**City of Bellevue
Development Services Department
Land Use Staff Report**

Proposal Name: BDR Bellevue IX Steep Slope Buffer Reduction

Proposal Description: Critical Areas Land Use Permit to demolish an existing home and construct two new homes, one per lot, located within a 50-foot top-of-slope buffer from steep slope critical areas and install mitigation planting.

File Number: 15-125481-LO

Figure 3

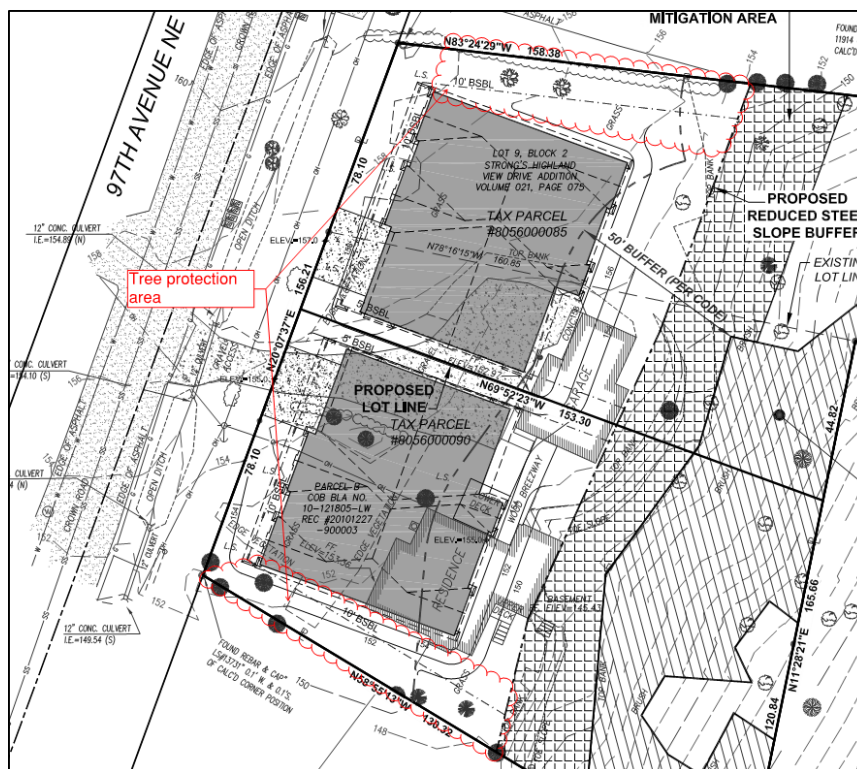
- The proposed extent of retaining walls along the property line that would have off-site impacts to the root zones of trees on the Peters property
- Trees proposed for retention on the project site
- Tree protection

Comments were addressed by staff requiring the proposed retaining walls to be removed and the site grading limited in order to conform to the construction performance standards in LUC

20.25H.125. The revised plans removed all freestanding walls along the property line and maintain existing grades within the root zones of the trees on Mr. Peters' property. As standard procedure, construction plans are required to have construction fencing and tree protection fencing meeting the City's clearing and grading code requirements and Best Management Practices. The extent of grading is only that which is necessary for construction and full site clearing or mass grading is not allowed. The current plans do not depict any permanent grade changes near the trees located on the Peterson property. However to ensure no offsite impacts to the slope buffer results from temporary construction impacts, tree protection fencing placed on the project site to protect the root zones is required in the areas noted in figure 3 below.

Any earthwork between the proposed house and the property line adjacent to the Peters property is required to have an arborist on-site to direct this activity and be done with hand tools. The plans for the future clearing and grading permit shall show this tree protection and have notes regarding work in the area. The plans shall also show all trees on the project site and confirm the minimum tree retention is met. **See Conditions of Approval in Section X of this report.**
